Clarendon Boulevard (N Rhodes to N Oak St)

Community Feedback Summary

Final Concept Section 1

Final Concept Summary

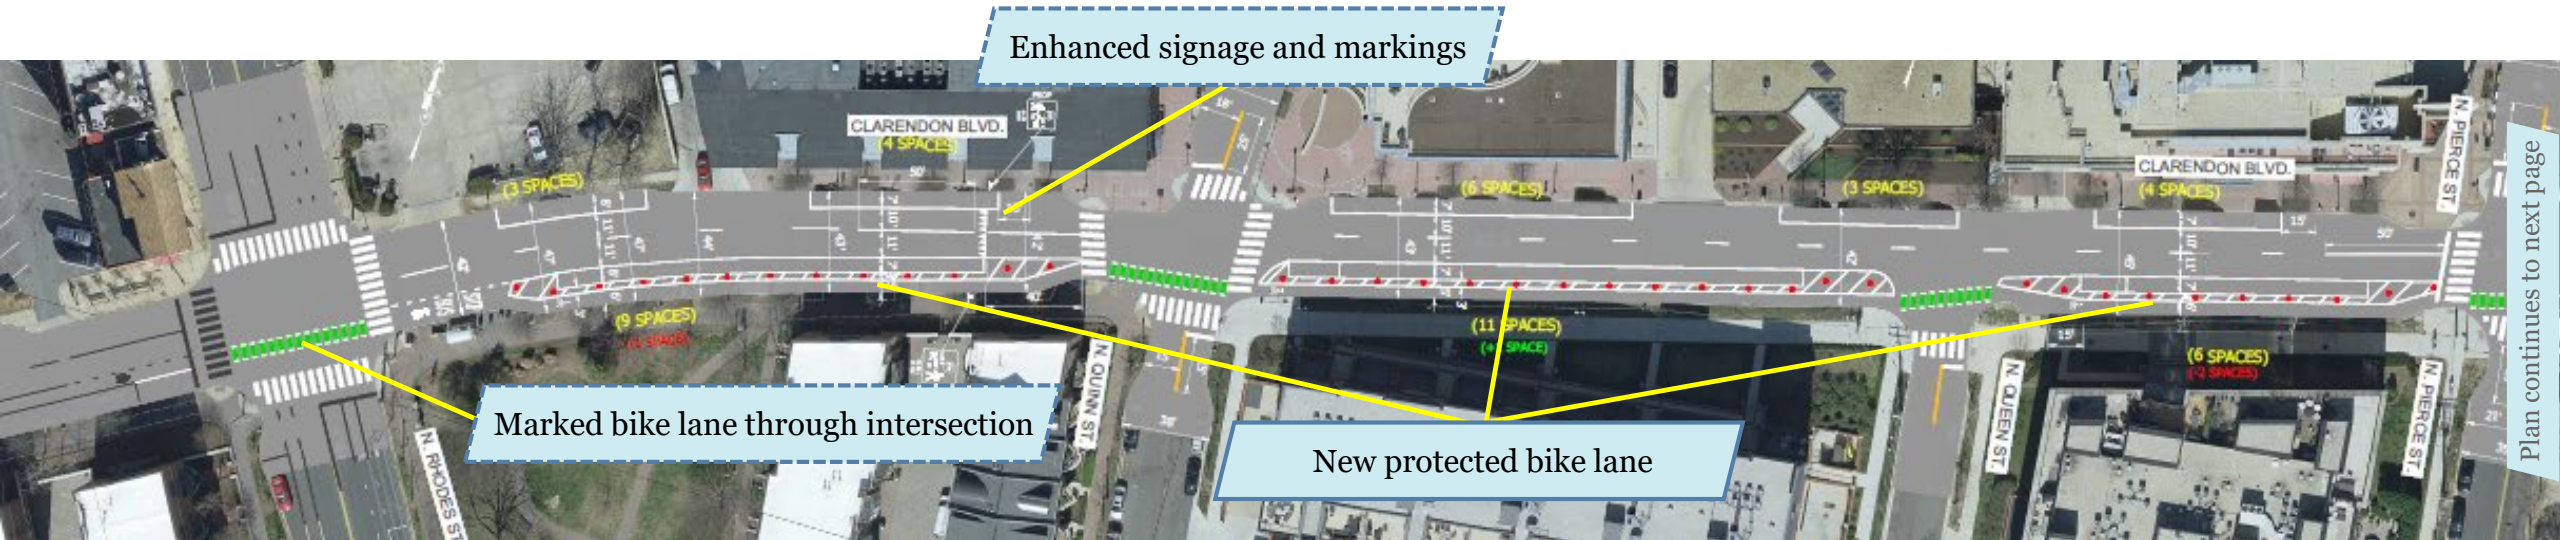
Feedback shared:	How final concept was adjusted:
General - Concern about visibility of pedestrian crossings	Marks all crosswalks and adds enhanced markings and signage at the unsignalized crossing at N Quinn St
N Rhodes St - Concern about conflict between people driving and people biking	Add green skip treatment through intersection to clarify movements
17th St N merge - Issues understanding right of way	Changes markings and buffers added to make the exit to 17 th St N more pronounced
N Oak Street - Desire for an easier left turn for people biking	Marks a 2-stage bike turn box at Clarendon Boulevard and Oak Street to facilitate left turning bicycle movements
N Oak Street - Desire to clarify/offer vehicle turn guidance	Refreshes vehicle turn markings

- Marks bike lane through intersections with green markings
- Enhances signage and markings at N Quinn Street
- Refreshes vehicle turn guidance markings at N Oak Street
- Adds a 2-stage turn box for bicyclists at N Oak Street
